Advanced Composite Textile Ltd

Kashor, Masterbari, Bhaluka, Mymensingh, Bangladesh
(24.302157N, 90.363604E)

24th October 2015

ACCORD
on Fire and Building Safety in Bangladesh

High Stress Levels in Columns

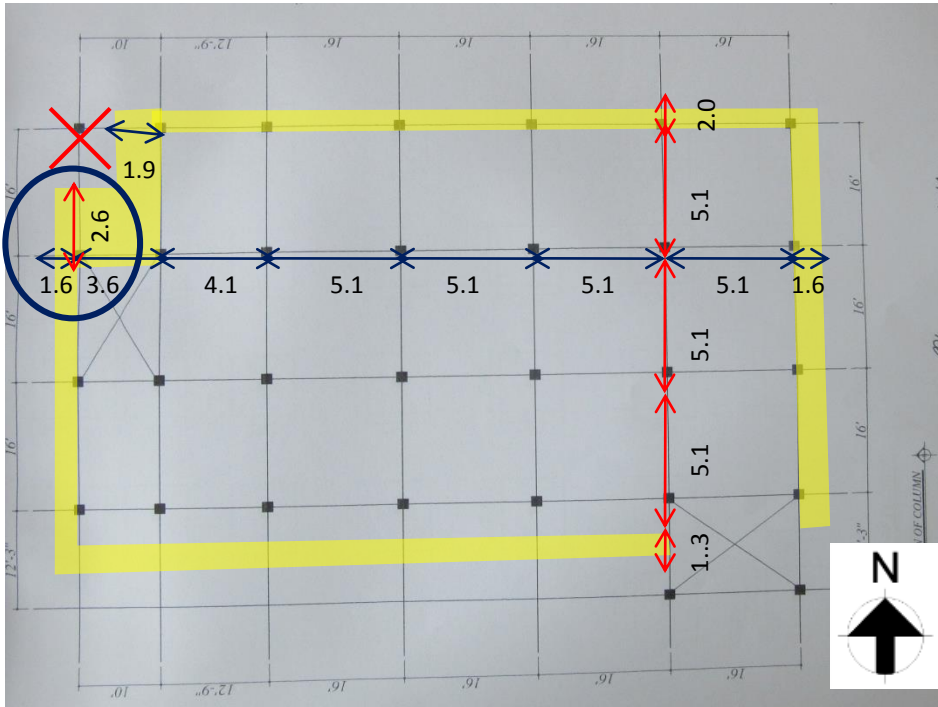
Outline calculations indicate some columns are highly stressed under their current loading conditions particularly in the areas highlighted.

Quick Ferro scanning on column

Concrete has Stone aggregate

Item No.	Observation	Recommended Action Plan	Recommended Timeline
1	High stress levels in columns (B1 and B2)	Factory Engineer to review design, loads and columns stresses in all columns	6-weeks
2	High stress levels in columns (B1 and B2)	Factory Engineer to verify insitu concrete strength by taking 100mm diameter cores from 4 columns . Verify grade of steel reinforcement used.	6-weeks
3	High stress levels in columns (B1 and B2)	Produce and actively manage a loading plan for all floor plates within the factory giving consideration to floor capacity and column capacity.	6-weeks
4	High stress levels in columns (B1 and B2)	Make any structural alterations as advised by Engineer.	6-months
5	High stress levels in columns (B1 and B2)	Continue to implement load plan	6-months

High Stress Levels in Columns

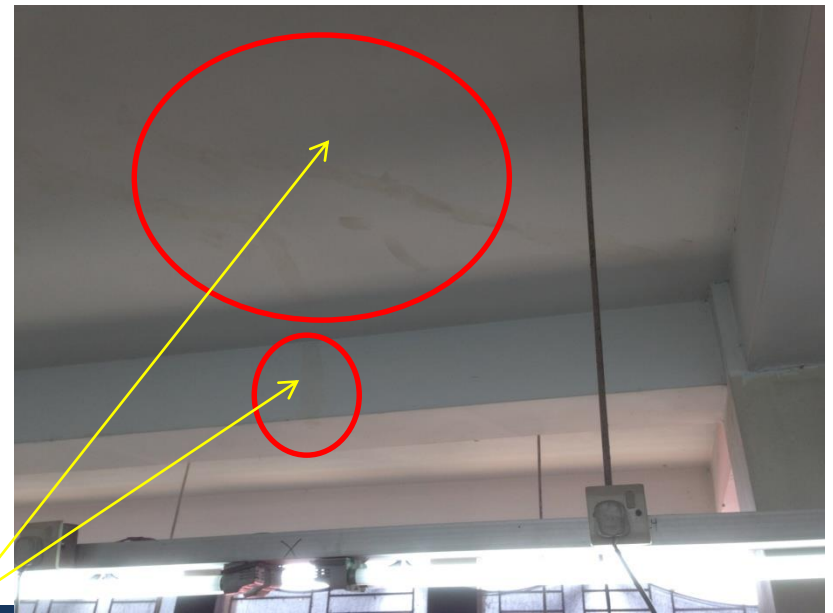
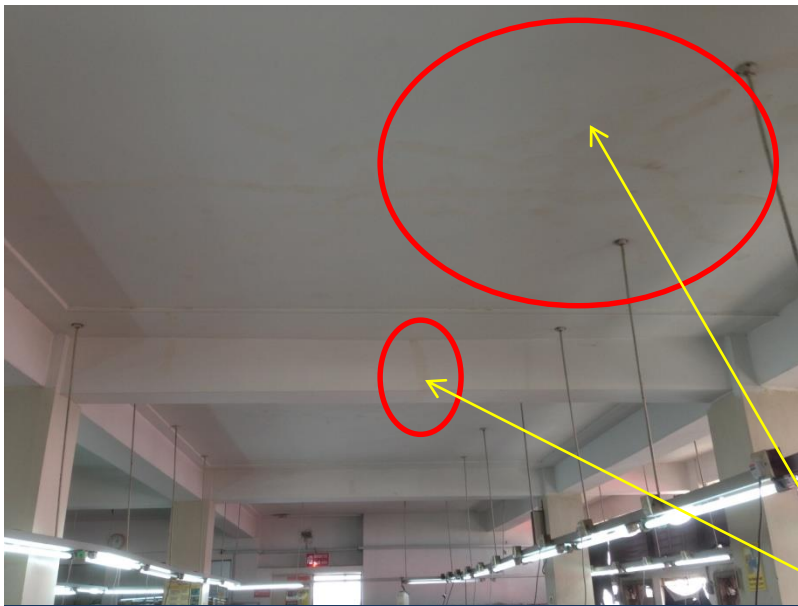
Observation BLG 1

Outline calculations indicate some columns are highly stressed under their loading conditions particularly if all floors under construction are built up to building permit level (6th floor)

Cracking on some beams and slabs (BLG 1 and BLG 2)

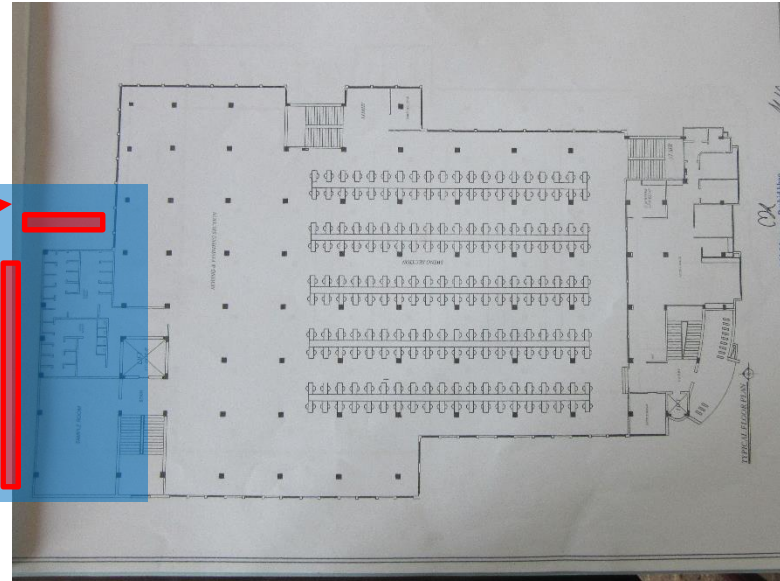
Cracks in roof slab and in beam observed in Building 1

Observed cracks in floor slabs in Building 2

Item No.	Observation	Recommended Action Plan	Recommended Timeline
9	Cracking on some beams and slabs (BLG 1 and BLG 2);	Portions of floor finish to be removed to investigate if cracks penetrate the building slab structure. Building Engineer to review further if cracks are found to penetrate into building structure.	6-weeks
10	Cracking on some beams and slabs (BLG 1 and BLG 2);	Carry out repair remedial works as required.	6-weeks
11	Cracking on some beams and slabs (BLG 1 and BLG 2);	Continue to monitor for cracking on an on-going basis	6-months

Discrepancies between site observations and information on drawings

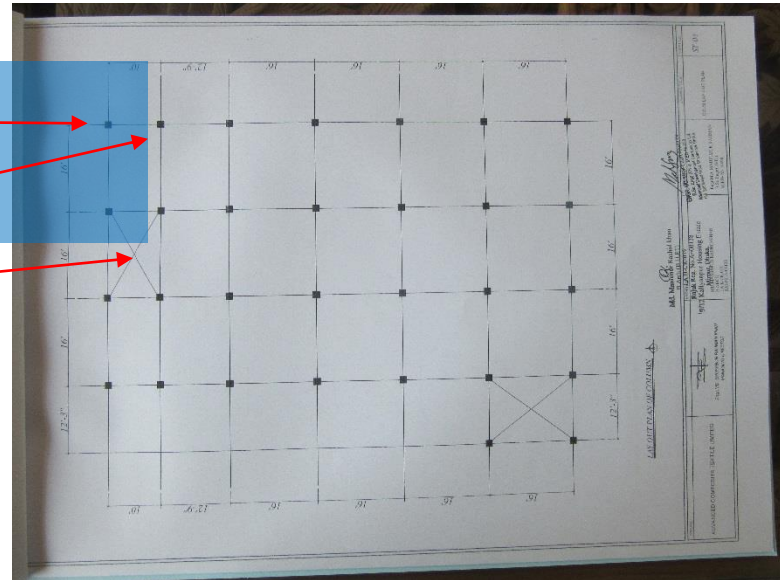
Building 1 – cantilevers not included in the drawings (area highlighted)

Column missing

Building 2 – the area highlighted observed on site seems different from what is included in the drawings

Item No.	Observation	Recommended Action Plan	Recommended Timeline
12	Discrepancies between site observations and information on drawings	Update the drawings	6-months
13	Presence of almost 1m soil in some cantilevers of BLG2;	Remove soil from the cantilever;	6-weeks
14	Presence of almost 1m soil in some cantilevers of BLG2;	Carry out any remedial work as directed by the Factory Engineer.	6-months
